## 6 Technical Feasibility of NG-EPON

### 6.5 Optical Transmitters

**Figure 139: Total volume of fixed and tunable transceivers shipped (left image) and observed cost of fixed and tunable transceivers (right image)**

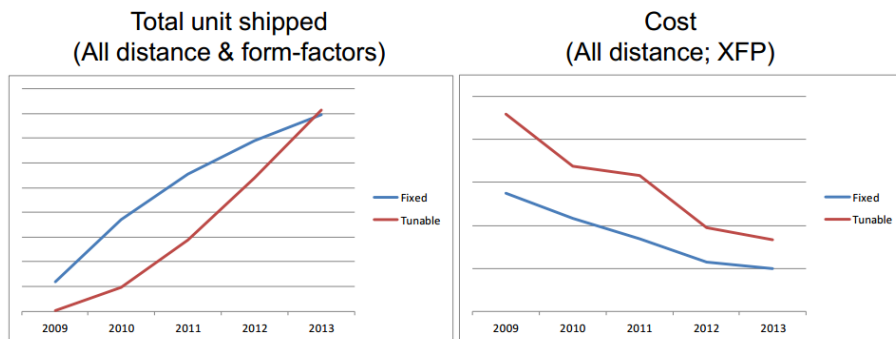
*Editorial Note (to be removed prior to publication): We can't put actual or average costs in (that's a stupid requirement for this report), but we should at least have a relative scale on the Y-axis to compare fixed v tunable in these charts.*

Figure 240: Tunable filter and its characteristics

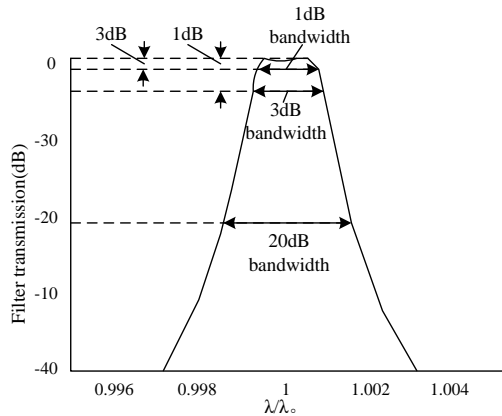
*Editorial Note (to be removed prior to publication): The only thing discussed in section 6.6 is tunable filters. We need additional content to talk about the PD or we need to rename this section to Tunable Filters.*

Figure 44: Three topologies of micro ring tunable filters

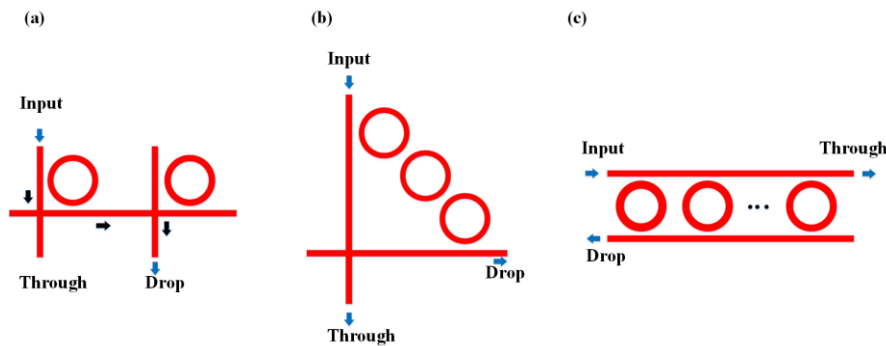
**Commented [MH12]:** Added to tie in the text on topologies of filters.
